Delegated Report	Analysis sheet		neet	Expiry Date:		05/02/2025			
(Refusal)	N/A	A / attach	ed	Consult Expiry		19/01/20	025		
Officer Jaspreet Chana			Application Nu 2024/5512/P	ımber(s)				
Application Address			Drawing Numb	ers					
58 Kingsway			Please refer to	decision	notice				
Holborn London									
WC2B 6DX									
PO 3/4 Area Tea	m Signature (C&UD	Authorised Of	ficer Sig	nature				
Proposal(s)									
Installation of 3 no. antenna on support poles together with 1 no. equipment cabinet and ancillary development thereto on the rooftop									
Recommendation(s):	i) Prior Approval Required ii) Prior Approval Refused								
Application Type:	GPDO Prior Approval Determination								
Conditions or Reasons for Refusal:									
Informatives:	Refer to Draft Decision Notice								
Consultations									
Adjoining Occupiers:	No. notified	00	No. of responses	00	No. of o	objections	00		
Summary of consultation responses:	A press notice was published 26/12/2024, which expired 19/01/2025. A site notice was displayed 24/12/2024, which expired 17/01/2025. No responses were received during public consultation.

1.0 Proposed development:

- **1.2** In this instance, Prior Approval is s

Fig.2. Aerial view

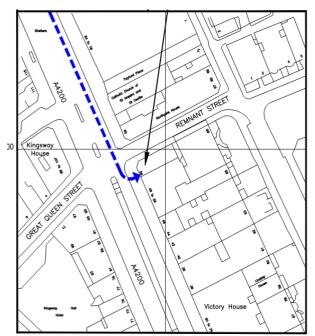
- **3.1** The host property is located in a prominent position at the corner of Remnant Street and Kingsway. The host building is a traditional designed building of merit with a corner prominent façade and is recognized as being a positive contributor within the Kingsway Conservation Area Statement.

3.2 The highest elements of the roof can be appreciated in views from various locations, including from both directions along Kingsway, Great Queen Street and Remnant Street. A screen shot of the street view from the junction demonstrates the prominence of the roofscape from this sensitive location, as below:

3.3 The image above clearly shows the lack of clutter along this roofscape where the host site and the neighbouring properties meet the skyline. The introduction of clusters of high antenna tripod structures at the roof edges projecting above the existing un-cluttered roofline is harmful in views from both sides of the site. It is accepted that the proposed cabinets would be unlikely to be visible due to their size and setback on the roof. The proposed installation is not considered appropriate in context and is not in keeping with the character of the Kingsway Conservation Area.
